# **Geotechnical Investigation**

## **Proposed Residential Development**

4386 Rideau Valley Drive  
Ottawa, Ontario

**re: Geotechnical Response to City Comments**  
**Proposed Residential Development**  
**4386 Rideau Valley Drive, Ottawa, Ontario**

# Figure 3 - Section A - Existing Conditions - Seismic Loading

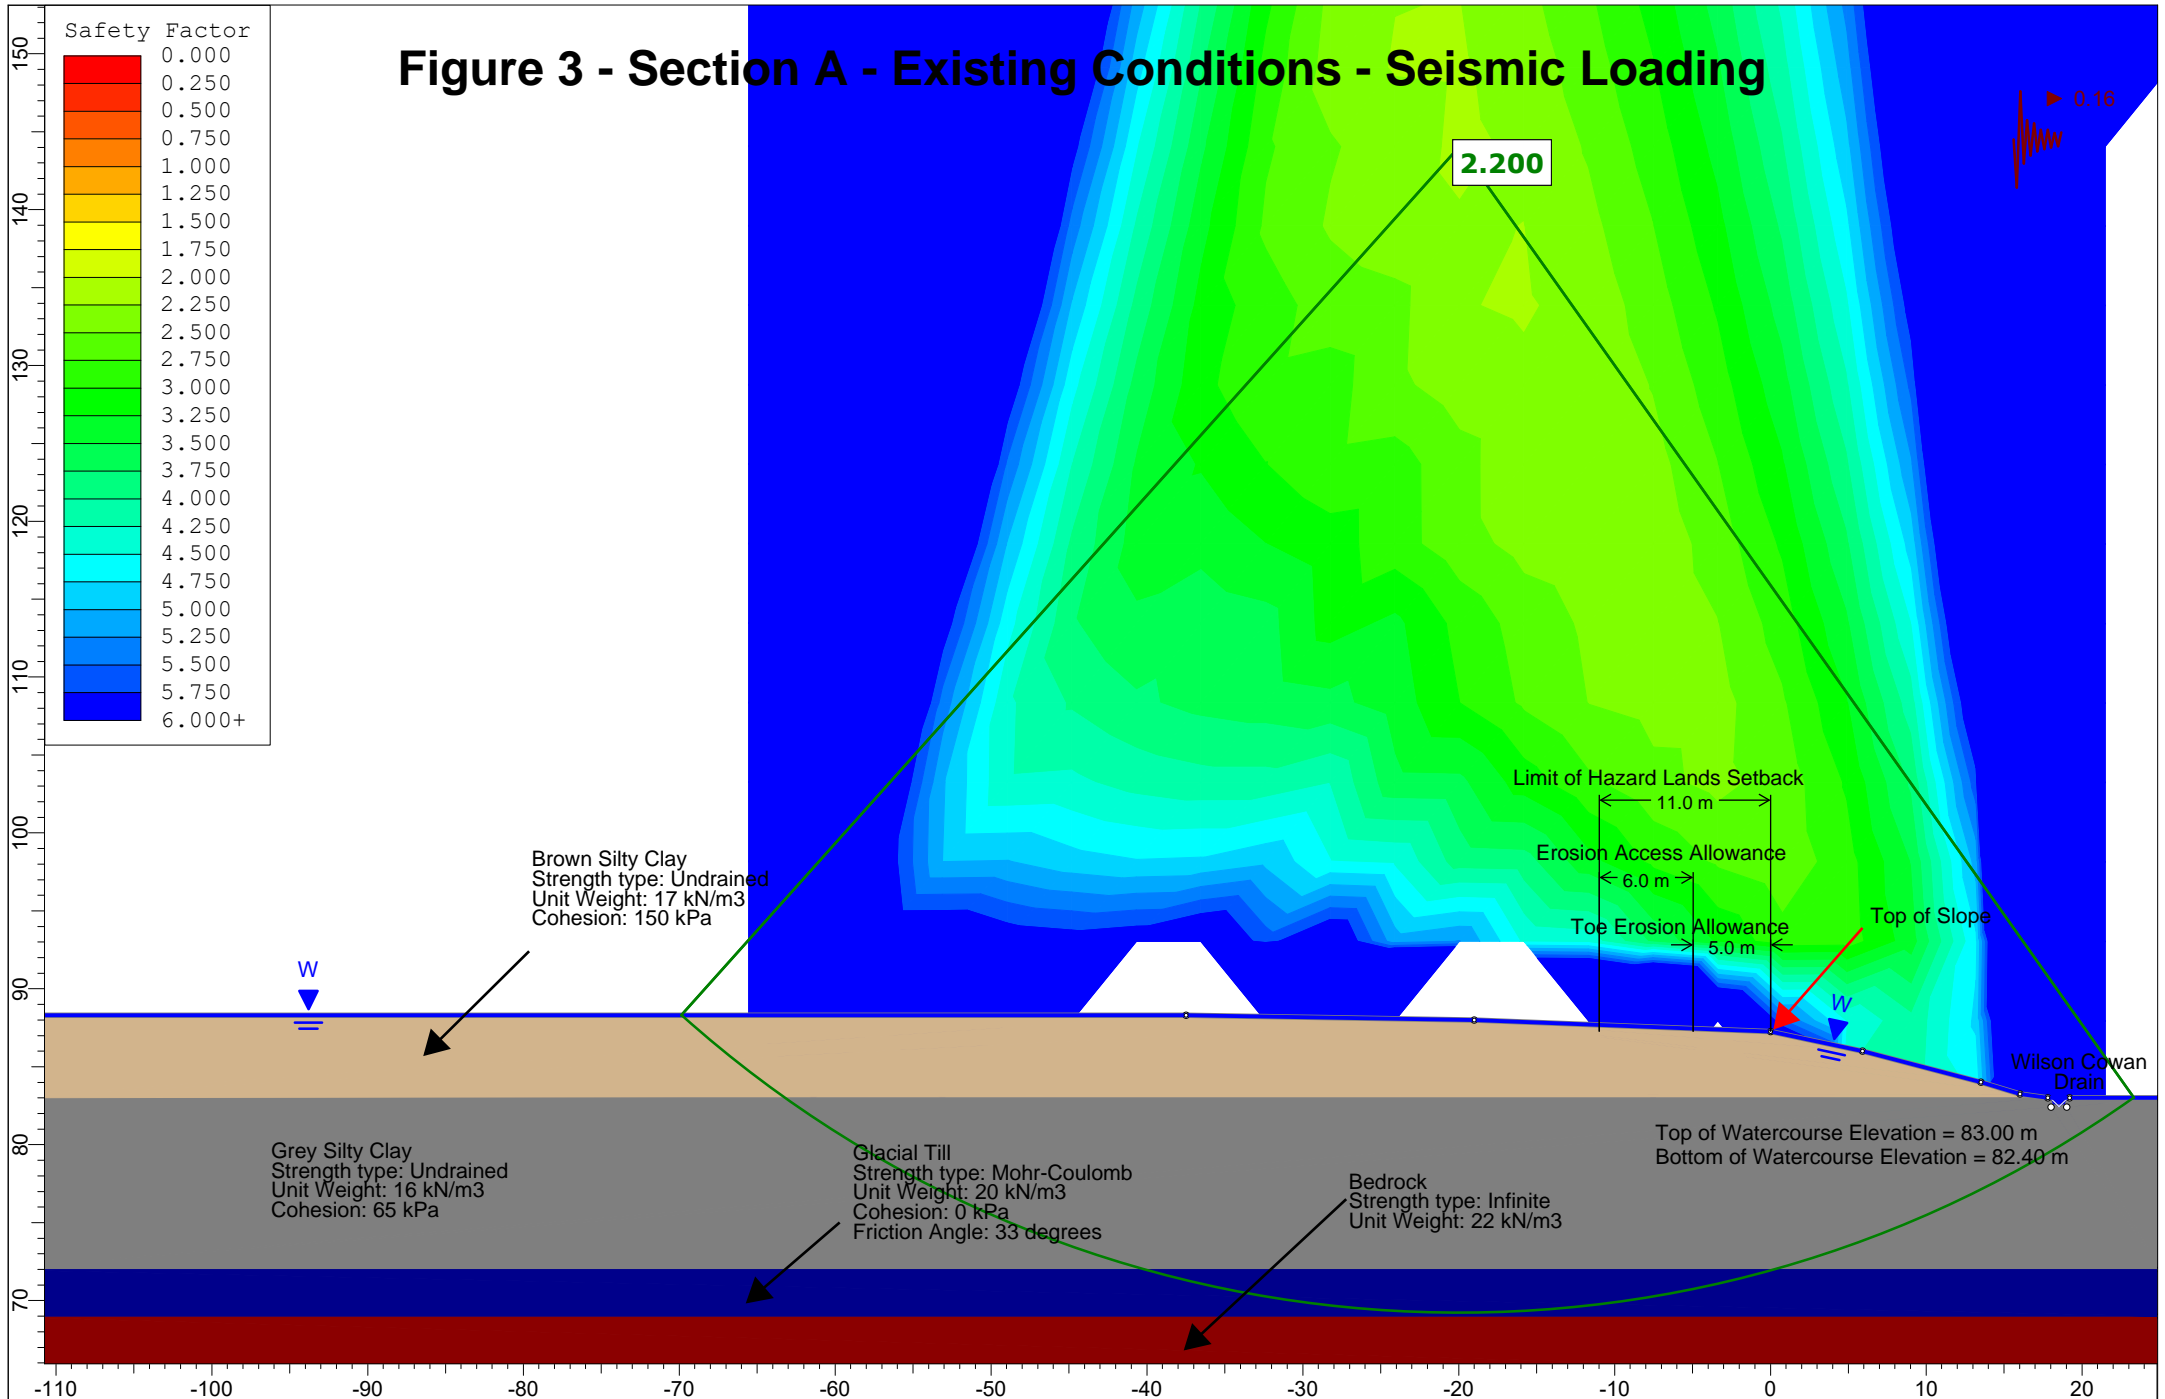
*The soil annotations on Figure 3 appear to be floating.*

**(City01): Comment 2.43** *The soil annotations on Figure 3 appear to be floating.*

**(City02): Outstanding:** *Referencing Figure 3, page 52 of 114, three soil types are indicated to be included in the slip circle. Also note that grey silty clay soils are a significantly weaker soil and not considered homogenous. The City will need to see a couple of non-circular failure surface calculations.*

Noted. The annotations for soil layers in Figure 3 have been modified in the above-mentioned revised report.

This comment has been acknowledged. Multiple non-circular failure surfaces have been added to Figure 3. Please refer to the above-mentioned revised report.

# Figure 4 - Section B - Existing Conditions - Static Loading

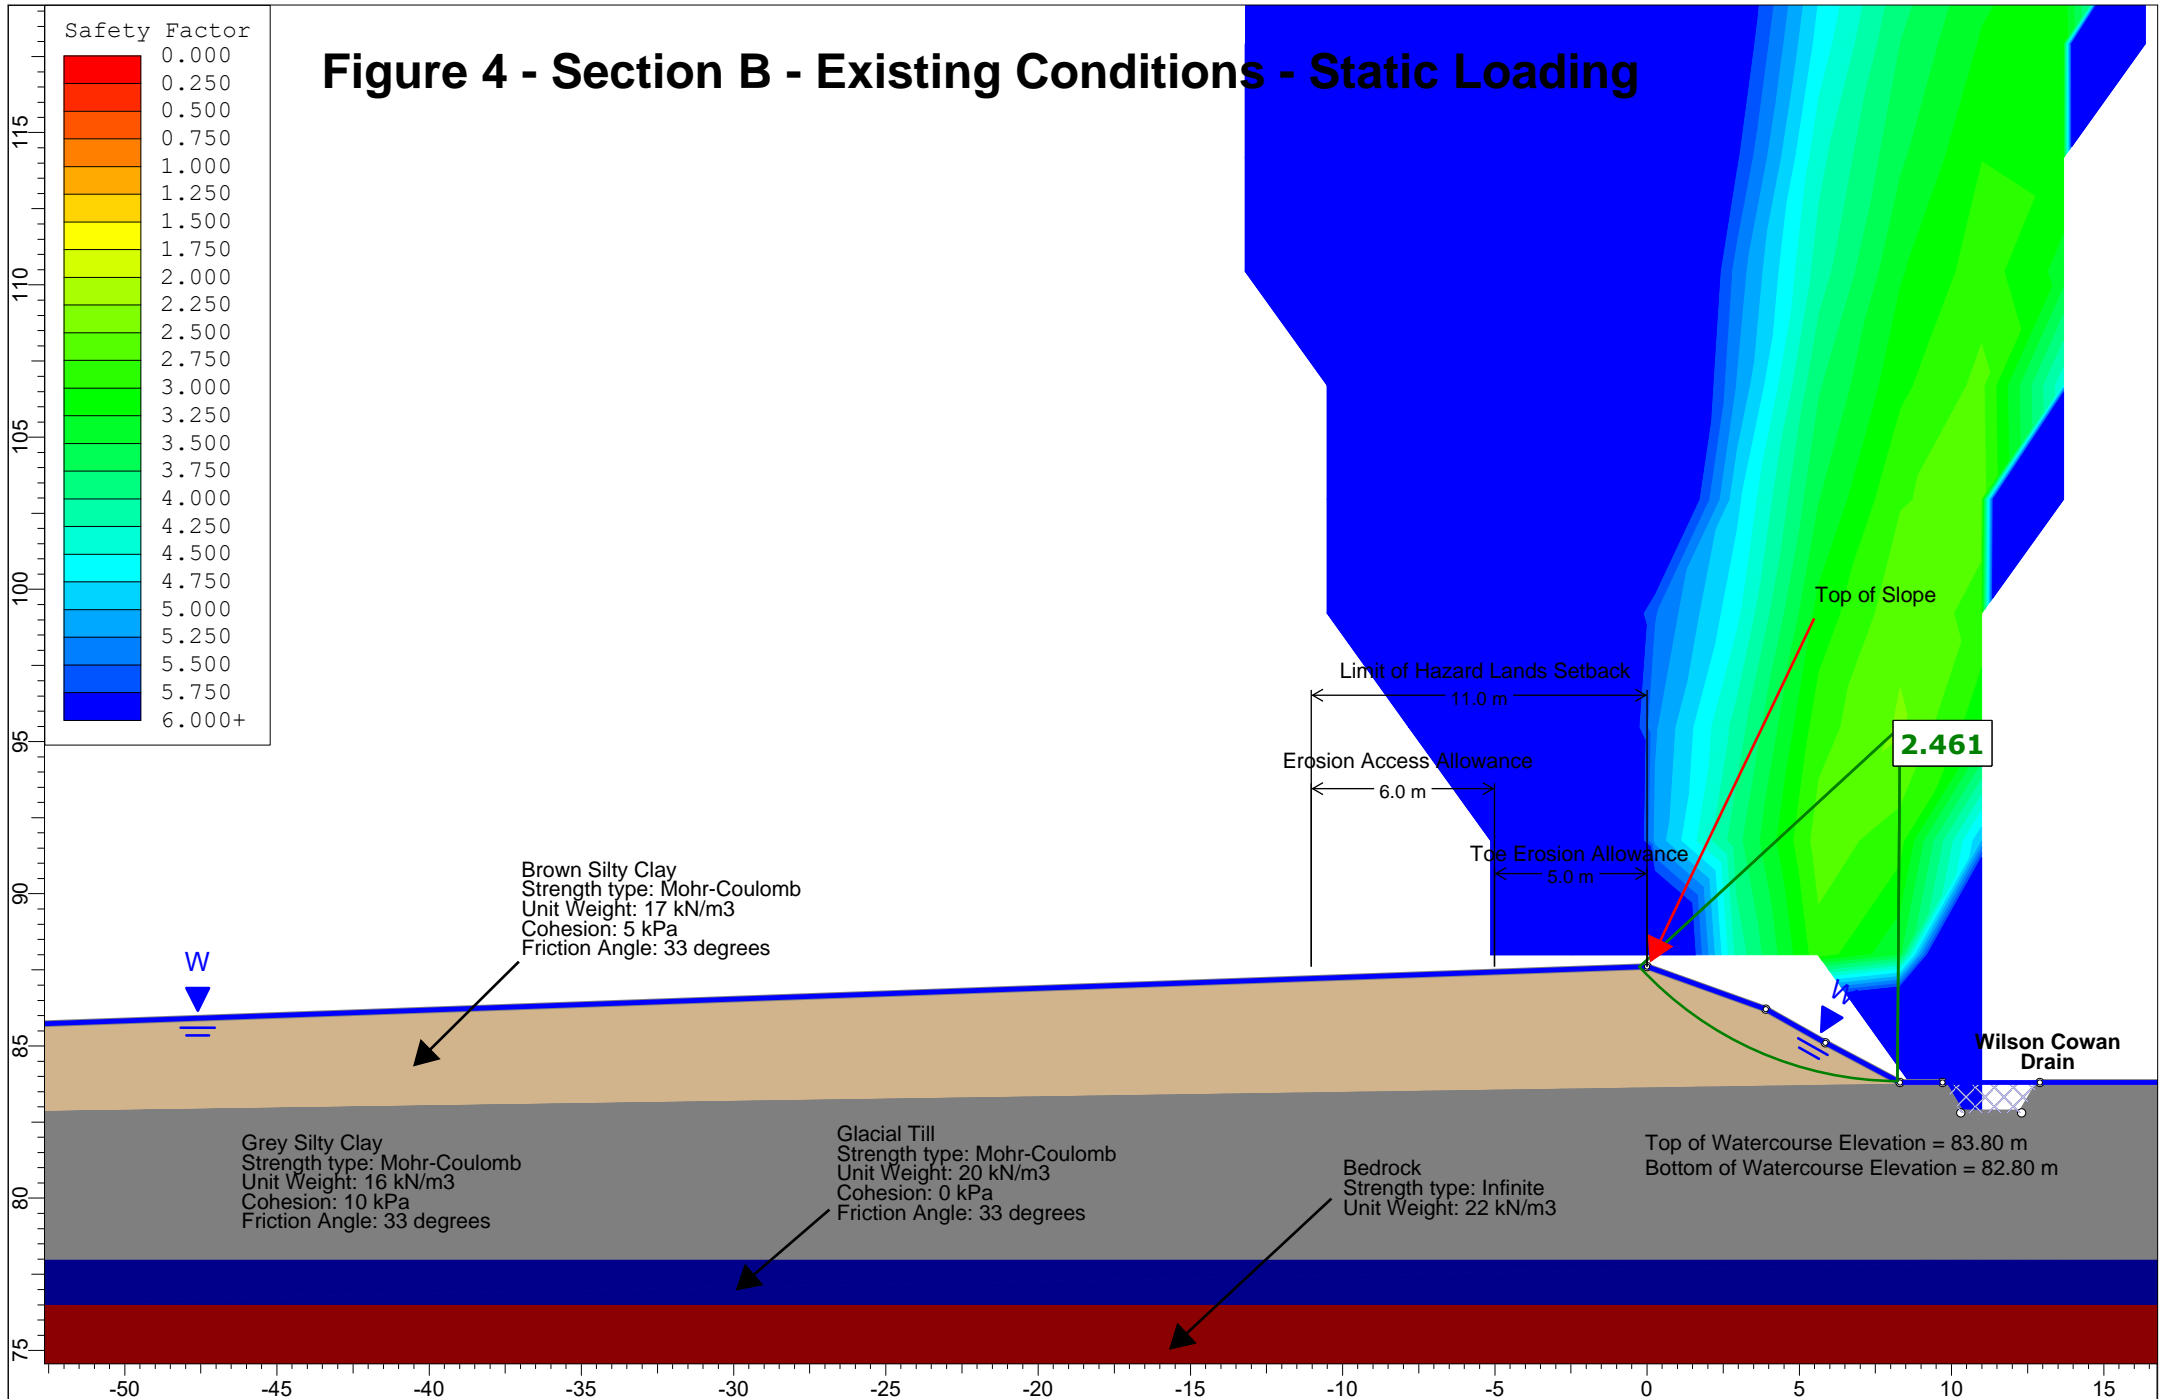
*Please include bathymetric survey data used for Figure 4 (amongst others).*

The bottom elevations of the watercourses at the studied cross sections has been determined using a high precision GPS, during our site visit to review the slope conditions. These elevations have been added to the slope cross sections included in the revised geotechnical report referenced above.

Figure 1. Criteria for evaluating liquefaction susceptibility of fine-grained soils (Bray et al. 2004).

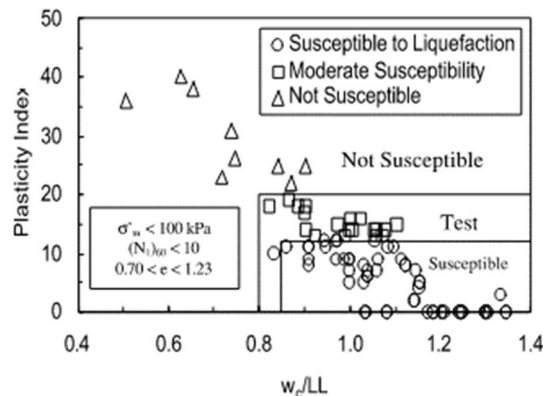
**(City01): Comment 2.27** *The comments that the subject site are not susceptible to liquefaction requires an exhaustive discussion: whichever approach the consultant takes will require proof of similitude and full copies of papers provided to the City showing unequivocal support.*

**(City02): Outstanding:** *While the City understands the comparison implied here, we need to see testing or other data that confirms that this specific site meets these requirements.*

Paterson's Previous Response: The soils encountered at the subject site consist of silty clays, which are cohesive in nature. These soils were evaluated for liquefaction susceptibility in accordance with the criteria prepared by Bray et al. 2004 which determines that all soils with a plasticity index exceeding 20% are not liquifiable (Figure 1). In general, the plasticity index results completed on samples taken from the silty clay layer were found to be above 20. Therefore, the encountered soils are not susceptible to liquefaction. Reference should be made to subsection 5.4- Design for Earthquakes in the abovementioned revised geotechnical report, for further details on liquefaction susceptibility at the subject site.
